Subject: MHI's Response to US-APWR DCD RAI No. 222-1933

Response to Request for Additional Information No. 222-1933
Revision 1

**US-APWR Design Certification
Mitsubishi Heavy Industries
Docket No. 52-021**

RAI NO.: NO. 222-1933 REVISION 1
SRP SECTION: 14.03.11 – Containment Systems and Severe Accidents –
Inspections, Tests, Analyses, and Acceptance Criteria
APPLICATION SECTION: 14.3.4.11
DATE OF RAI ISSUE: 2/26/2009

US-APWR DCD Tier 1 New Figure 2.11.4-1

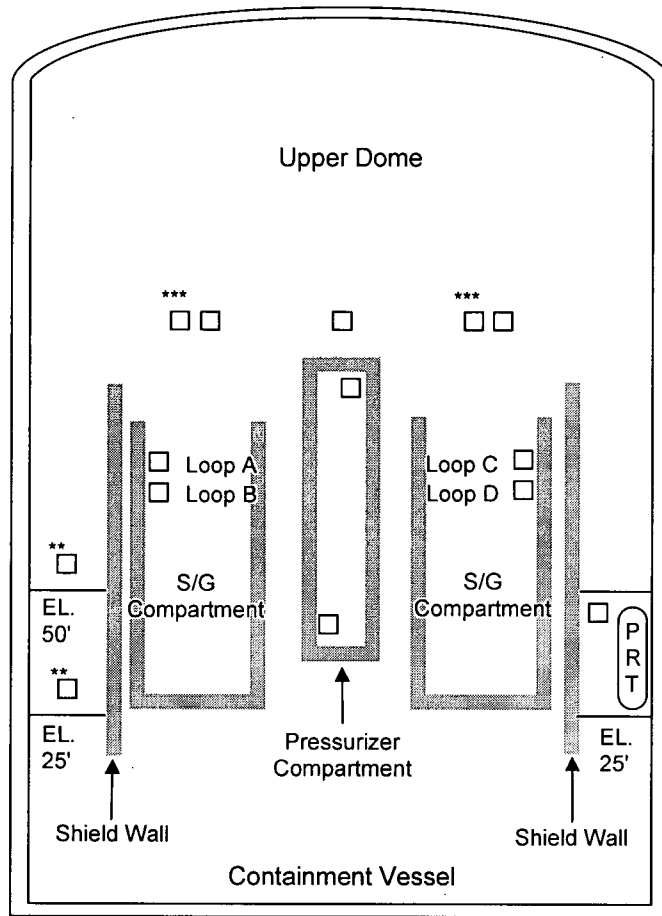
- 1) In addition to the DCD changes cited in the RAI 14.3.4.11-1 response, revise the DCD to add Tier 2 figure 6.2.5-1. Include ITAAC to verify the specific location of each hydrogen igniter in the containment.

MHI will add new DCD Tier 1 Figure 2.11.4-1, based on Tier 2 Figure 6.2.5-1. The CHS functional arrangement ITAAC (Item 1 in Table 2.11.4-1) and the CHS design description in Subsection 2.11.4 will be revised to refer to Figure 2.11.4-1. As requested, an ITAAC to verify the location of the hydrogen igniters will be added to Table 2.11.4-1. These changes will be coordinated with the changes to Subsection 2.11.4 previously described in response to RAI 14.3.4.11-1 (MHI Ref: UAP-HF-08183, dated September 18, 2008), and response to questions 14.03.11-20 and 14.03.11-24 of this RAI.

Figure 2.11.4-1 will be added to Tier 1 section 2.11.4 as shown in Attachment 1.
